PCU013798

**Re: Environmental Assessment – Major Project Application MP09_0191
34 Victoria Road (Marrickville Metro Shopping Centre), 13-55 Edinburgh Road and Part
of Smidmore Street, Marrickville**

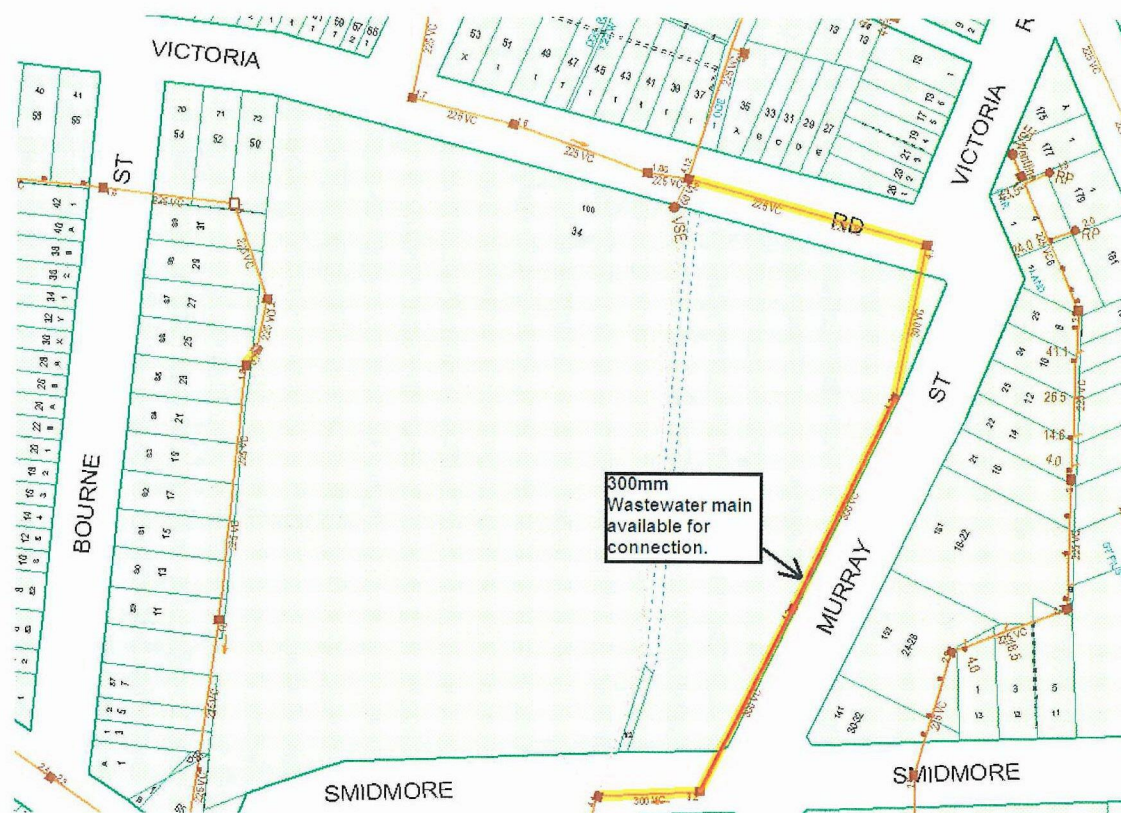
The wastewater system has sufficient capacity for the proposed development. The wastewater main available for connection is the 300 mm main constructed under WN 300833 as shown on the plan below.
